**Decisión nº / Decision nº:** GT-OPEN-18-17

**Asunto / Issue:** Equilibrio de Prestaciones (BoP)  
*Balance of Performances (BoP).*

**Fecha / Date:** 19/10/2017

Montmeló, 27, 28 and 29 October 2017

## Pboost limit definition

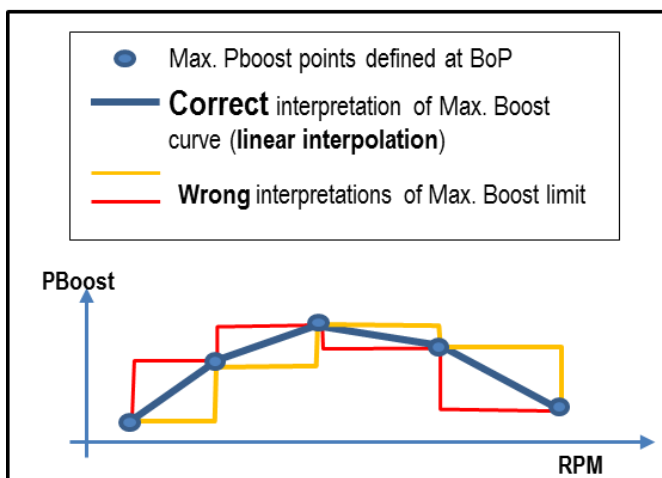
- BoP max. Pboost values are absolute ones (no tolerance applied) for an ambient pressure reference of **1010 mbar**.
- If real ambient pressure at the event is different from the reference value, the limit must be shifted, up or down, consequently (offset, not rate) . [Ej: if real ambient pressure at the event is 980 mbar, the limit must be decreased by 30 mbar (1010-980)].

• For the **WHOLE EVENT**, it will be considered as reference ambient pressure the one declared and fixed by the Technical Commission of the Championship **BEFORE** the first Free Practice on Friday.
